Access Compliance Report Public Rights-of-Way (Curb Ramps)

Main Street: O_NEILL_DR		Cross Street: HYDRANGEA_ST		Location:	NW
ADA ID: RPRK211111113940	Ramp Type: Type 4 - Parallel	Initial Pass/Fail: Fail	Overall Compliance: No	Severity Score:	15
Codes/Mitigation Info/Possible Solution			Field Measurements/Component Compliance

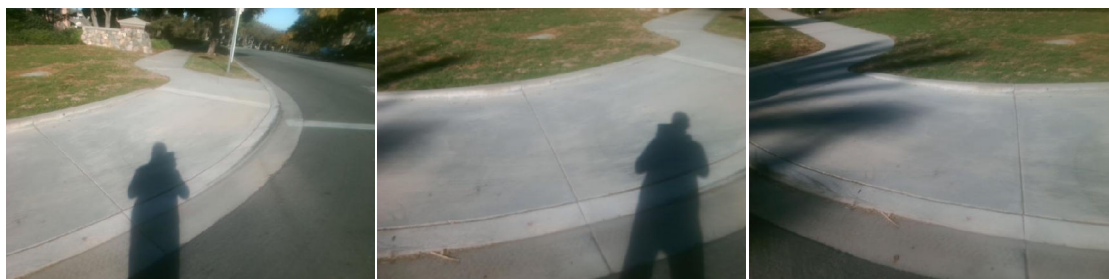
R204.3, R304.3.2, STD 1115

Remove & Replace Curb Ramp With Two New Directional Ramps or Equivalent.
